Product Change Notification

■Product List PCN2020-21_EF2-D30, EF2-D60 series housing end plate shape change

■ Changes PCN2020-21_EF2-D30, EF2-D30, EF2-D60 series housing end plate shape change

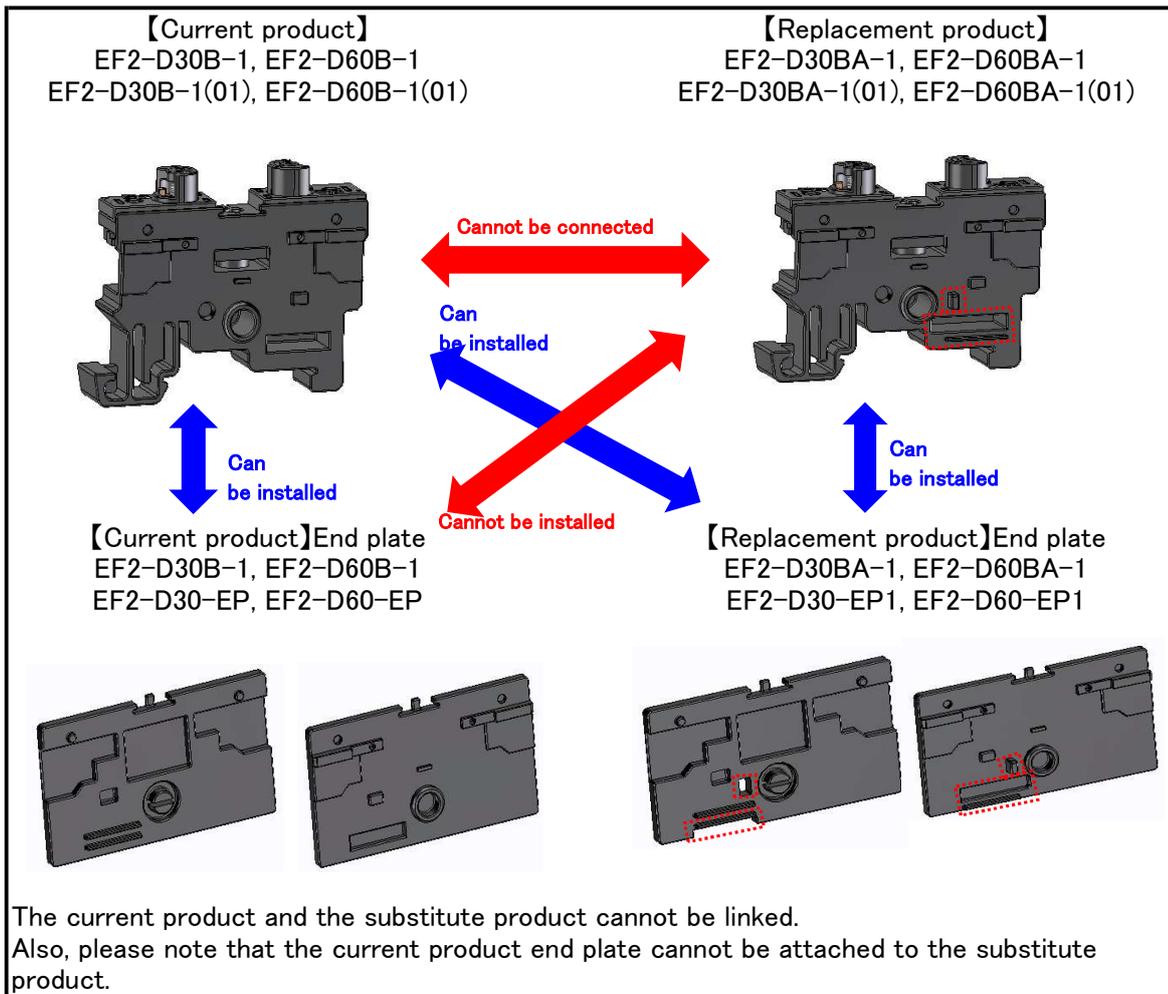
1	Products affected	Please refer to Attachment 1.
2	Replacement product	Please refer to Attachment 1.
3	Classification of change	Product specification change
4	Changes	We will change the shape of the housing and end plate. Please refer to the attachment 2 for details. <u>These changes will not affect the performances of the product.</u>
5	Reason for change	This is so that the newly developed hybrid type and the existing push type can be connected. Also, the end plate can be attached to both the hybrid type and the existing push type.
6	About product combinations	The current product and the substitute product cannot be linked. Also, please note that the current product end plate cannot be attached to the substitute product. Please refer to Attachment 3 for details.
7	Date of final reception of orders for the current product	November 30, 2021
8	Date of the first reception of orders for the replacement product	August 2, 2021

【Current product】	【Replacement product】
Housing	
<p>EF2-D30B-1, EF2-D60B-1 EF2-D30B-1(01), EF2-D60B-1(01)</p> 	<p>EF2-D30BA-1, EF2-D60BA-1 EF2-D30BA-1(01), EF2-D60BA-1(01)</p> 
End plate	
<p>EF2-D30B-1, EF2-D60B-1 EF2-D30-EP, EF2-D60-EP</p> 	<p>EF2-D30BA-1, EF2-D60BA-1 EF2-D30-EP1, EF2-D60-EP1</p> 
<p> ...Changes These changes will not affect the performances of the product.</p>
